SUBJECT: "Semiannual Radioactive Effluent Release Rept for Jul-Dec
1989." W/900301 ltr.

Subject: Palo Verde Nuclear Generating Station (PVNGS)
Units 1, 2, and 3
Semi-annual Radioactive Effluent Release Report
File: 90-A-056-026

OFFSITE DOSE CALCULATION MANUAL
PALO VERDE NUCLEAR GENERATING STATION
UNITS 1, 2, and 3

REVISION 3

FIGURE 6-2
REV. 12/89

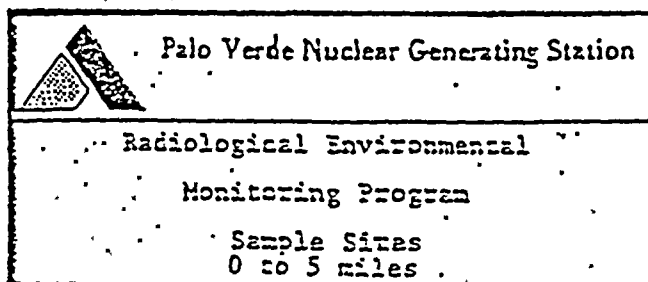
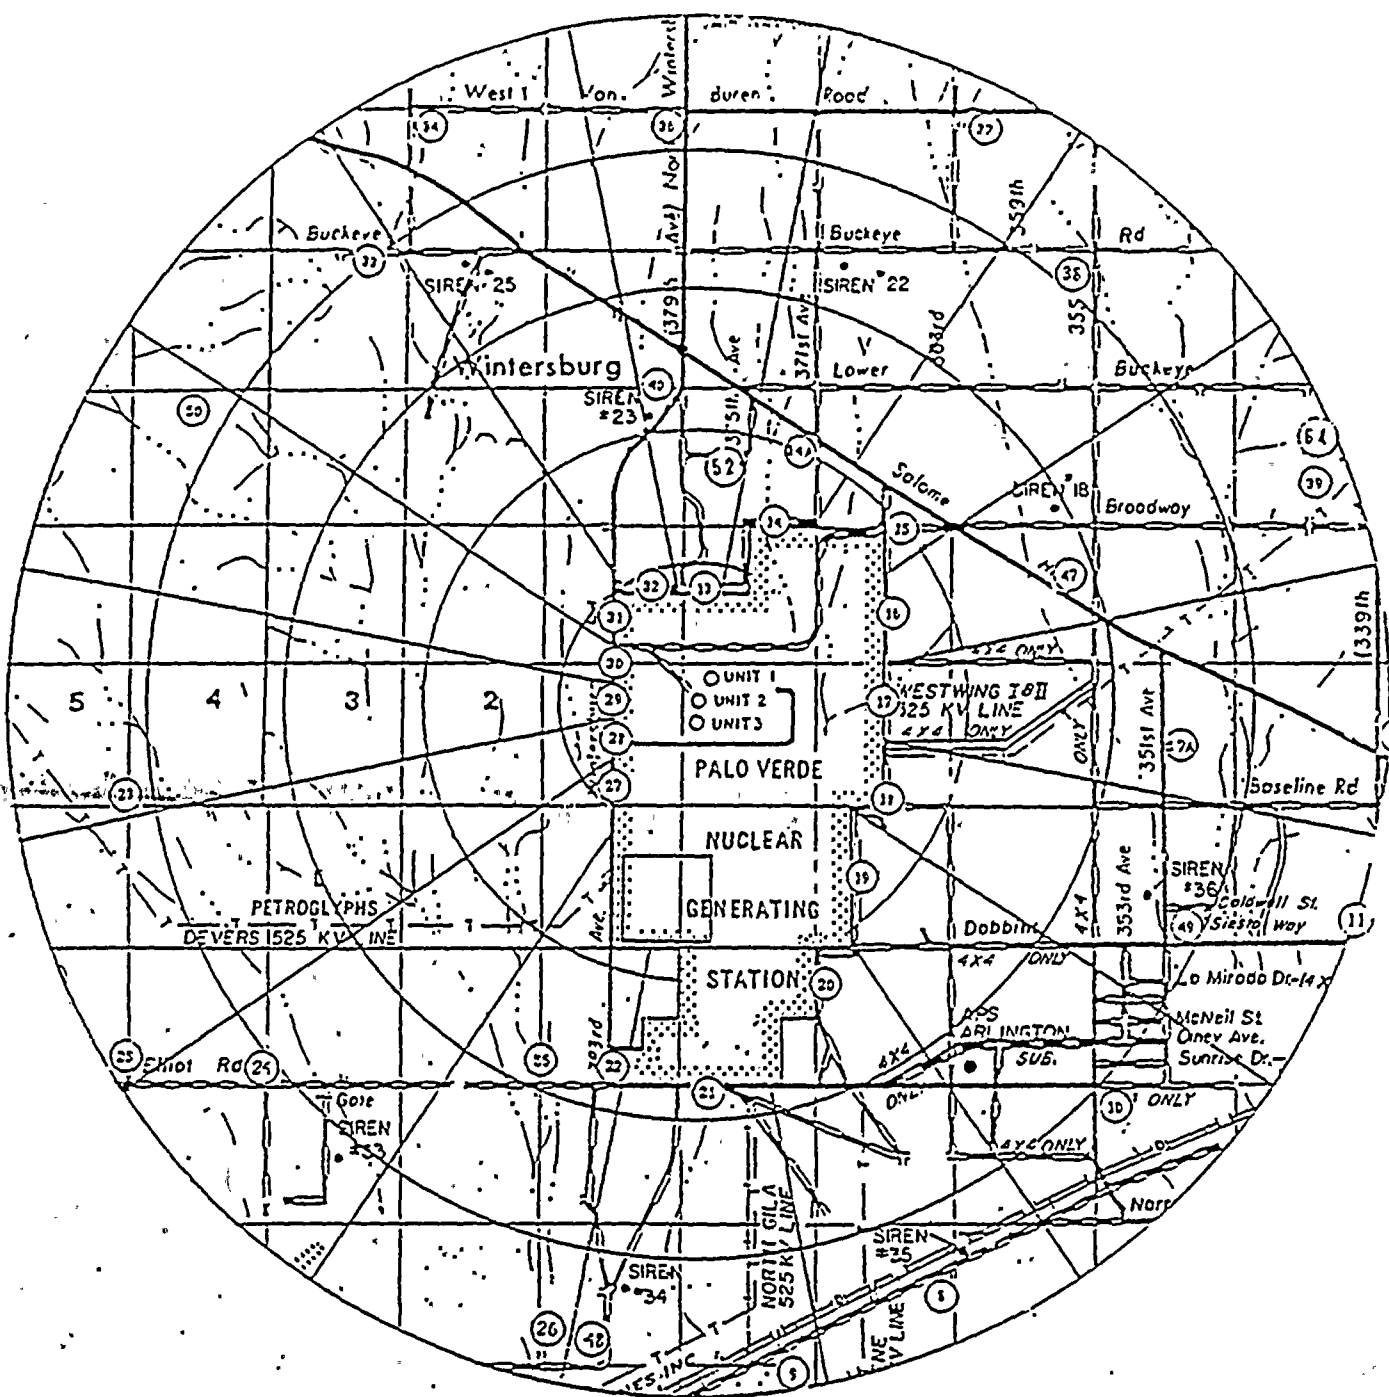
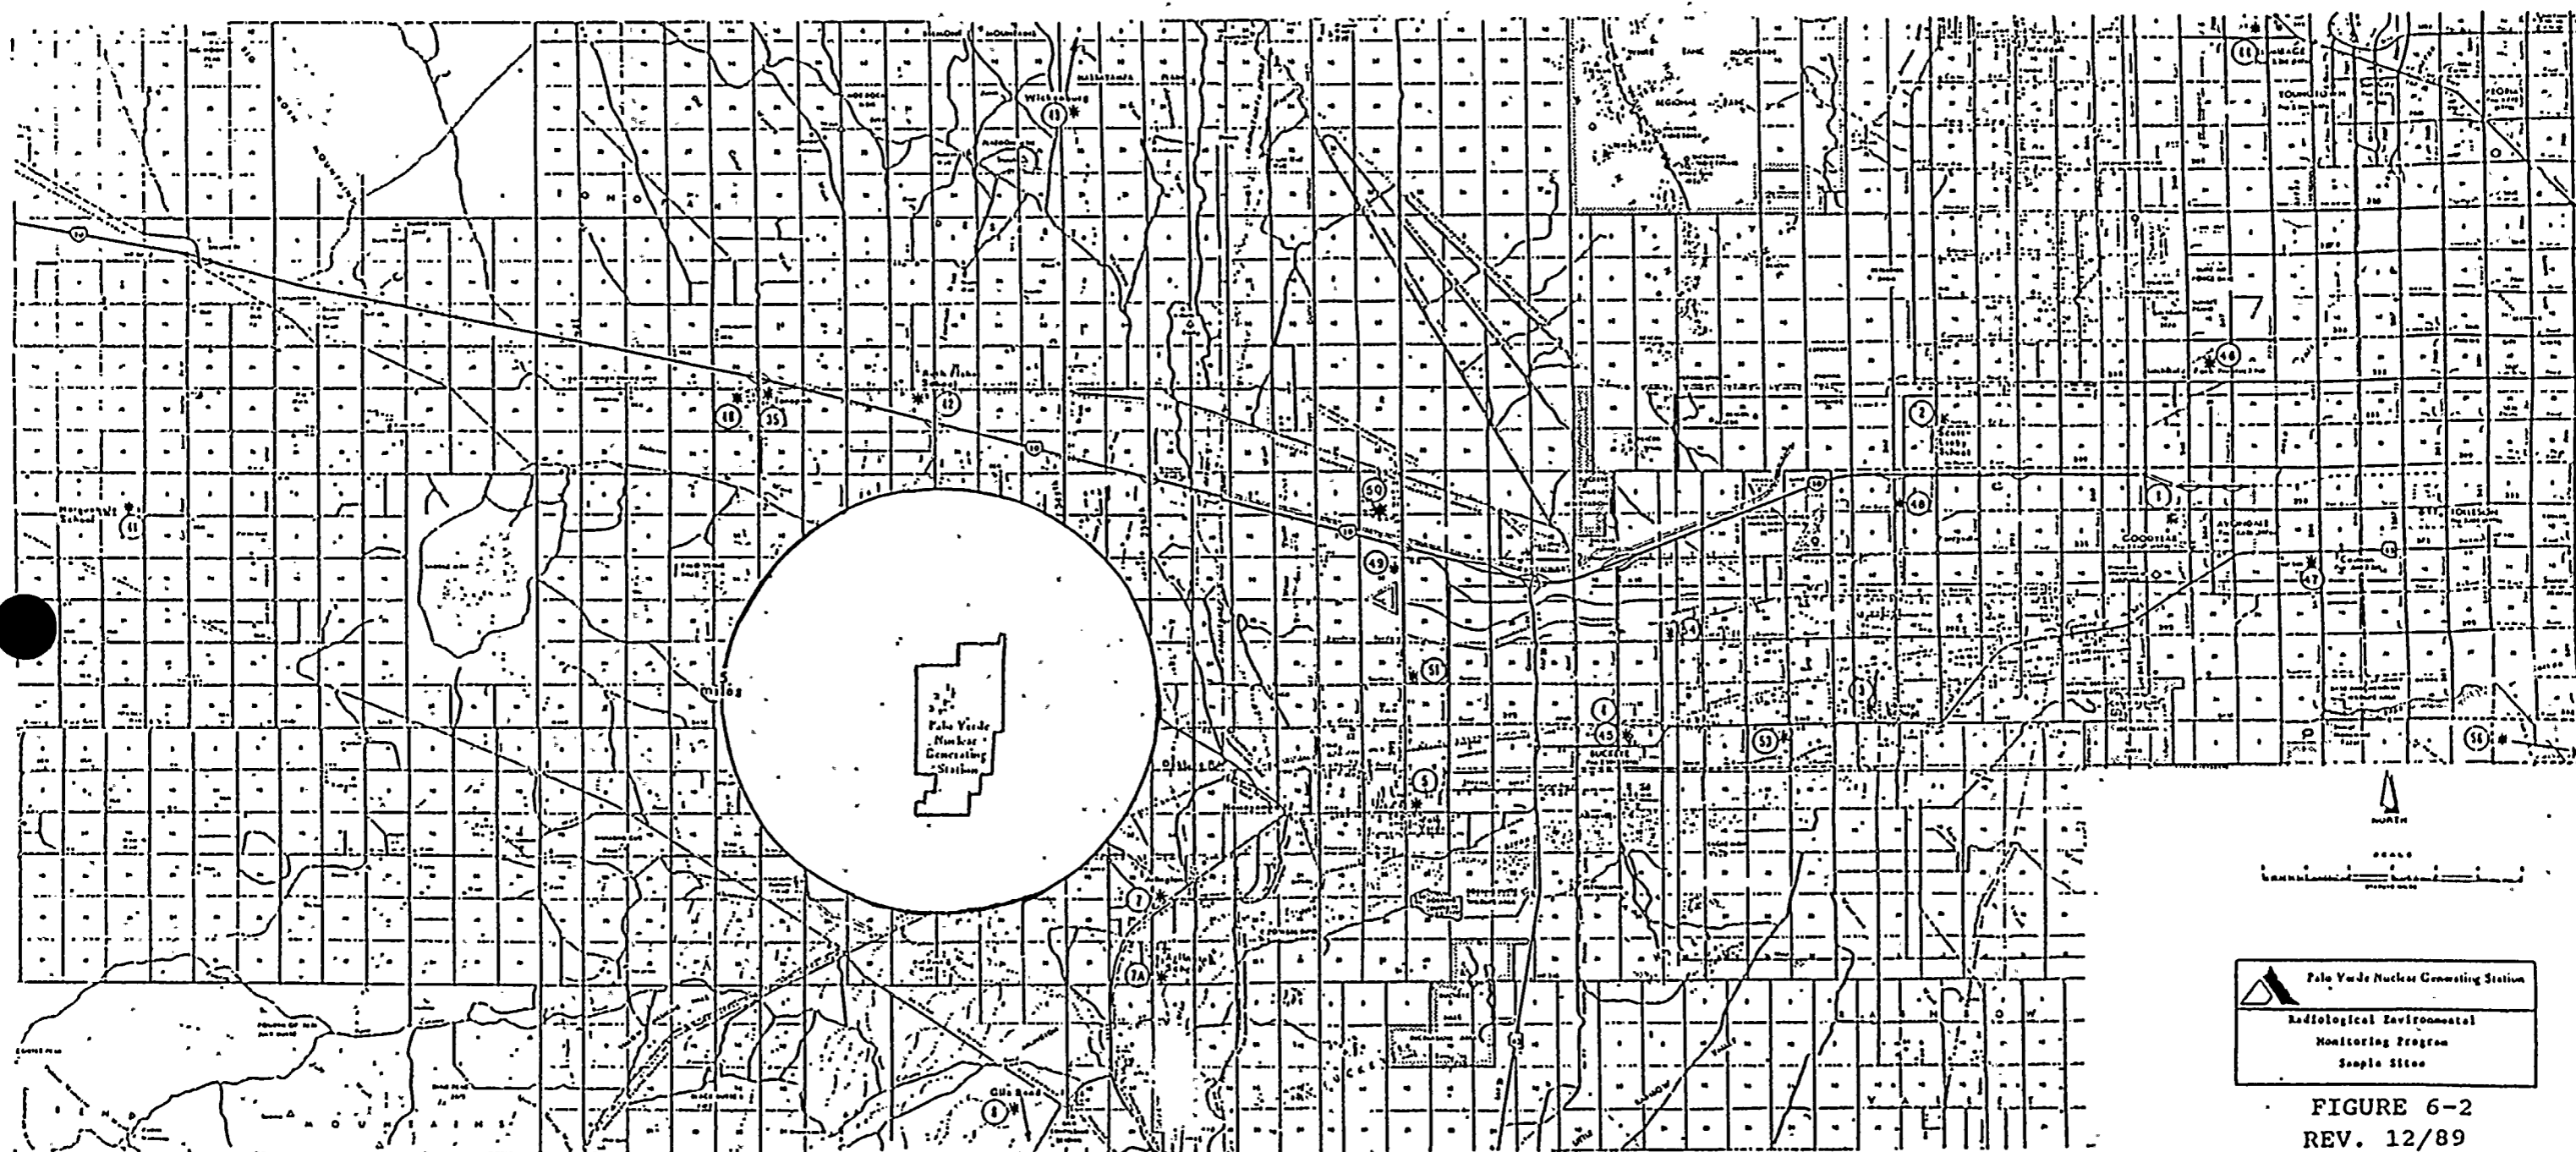
Table 6-1, Radiological Environmental Monitoring Sample Collection Locations, is in need of a revision to reflect changes in the sample locations since ODCM Revision 2. Additionally, Figures 6-1 and 6-2 will be revised to more accurately depict sample locations. The changes to be made are explained in detail on pages ^{LSD 12/11/89 34, 35, and 36} 2 and 3 of this submittal. The changes made will not reduce the accuracy or reliability of previous dose calculations and setpoint determinations. Upon completion of 75ST-92204, Land Use Census, which is in process as of this date, any changes in dose or dose commitment will be identified and reported. Note that per Technical Specification 3.12.1 action C, sample site #50 (milk) and #52 (vegetation) are required to be reported as revised sample locations in the next Semi-Annual Radioactive Effluent Release Report. Sample site #64 (goat milk) also falls within this reporting criteria.

ODCM Rev. 3 also includes revised Figures 6-1 and 6-2 to reflect the sample location changes made on Table 6-1. These figures are nothing more than maps showing relative sample locations.

Appendix A Page 1 of 1

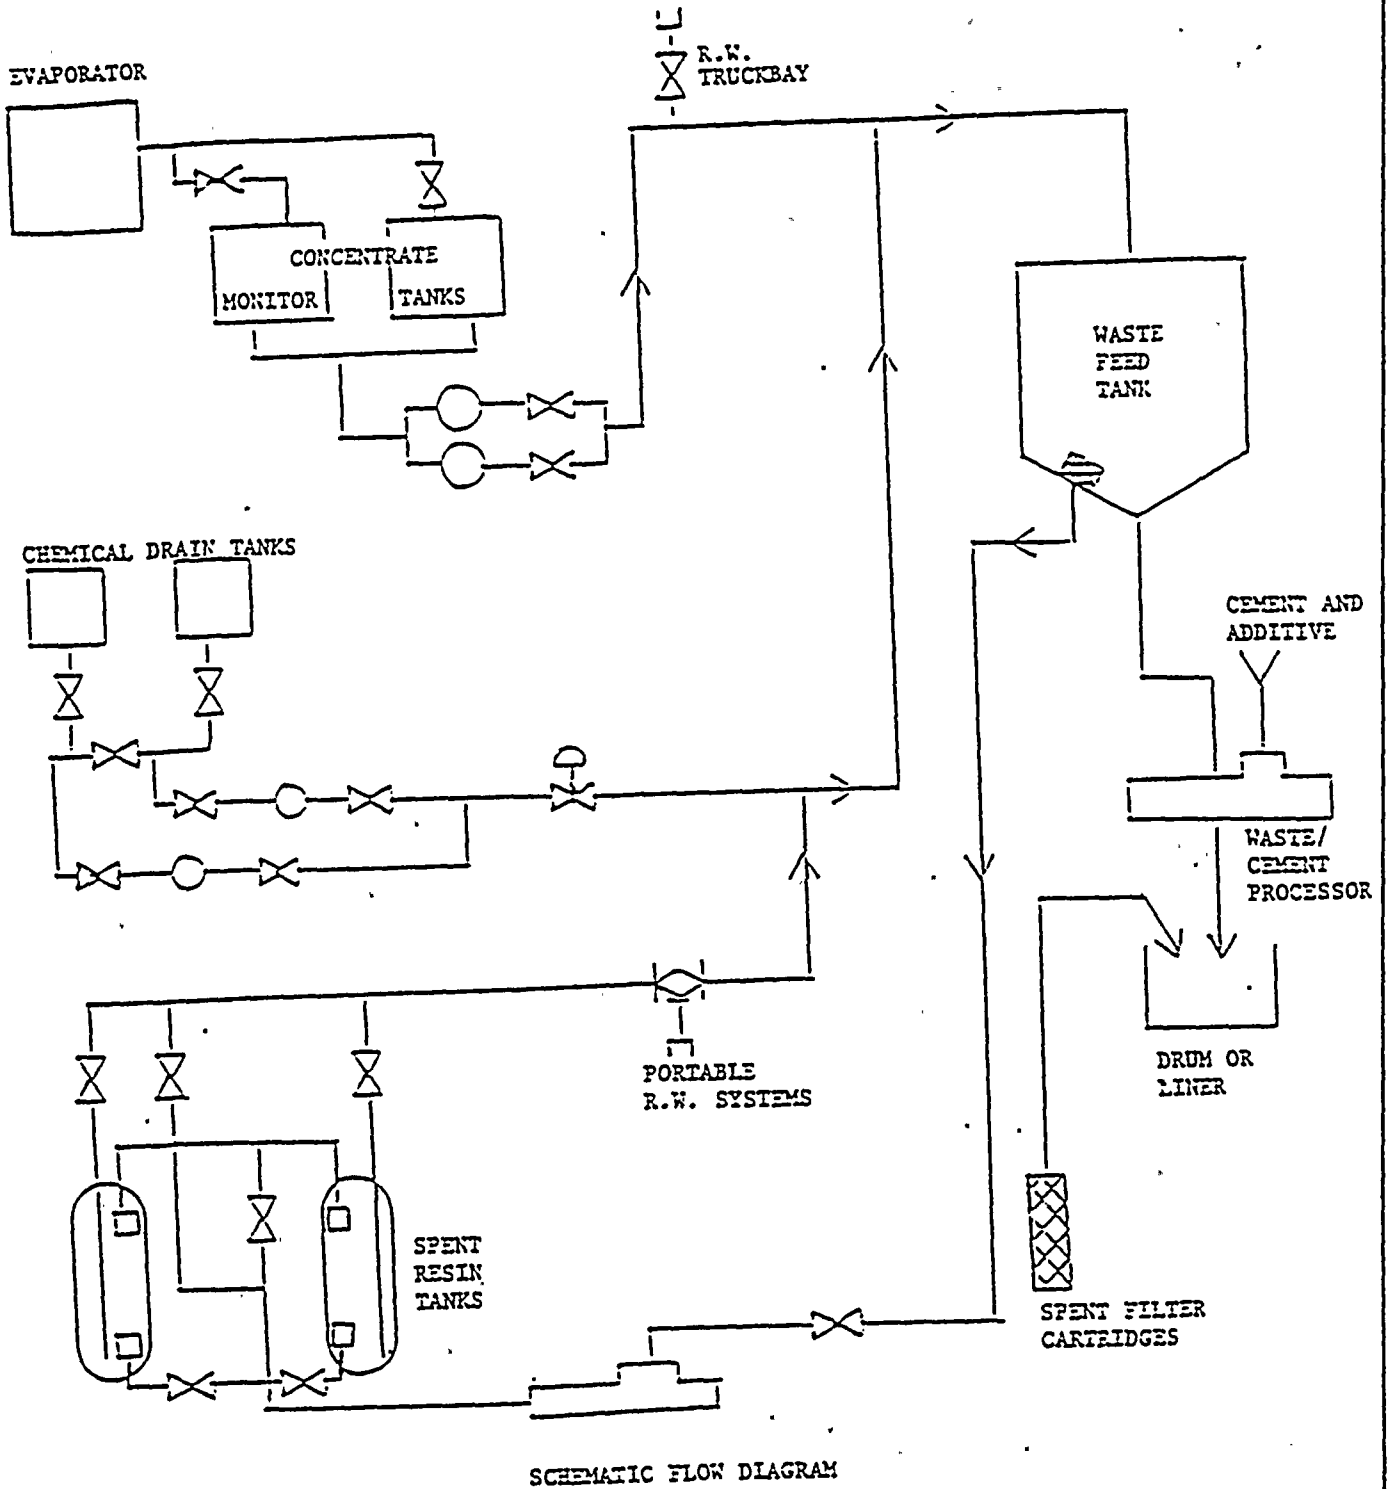
Appendix A; Added "R.W. Truckbay" and "Portable R.W. System" connections to schematic drawing.

Revised Appendix A, schematic drawing to show Radwaste truckbay connection and Portable Radwaste System connection.
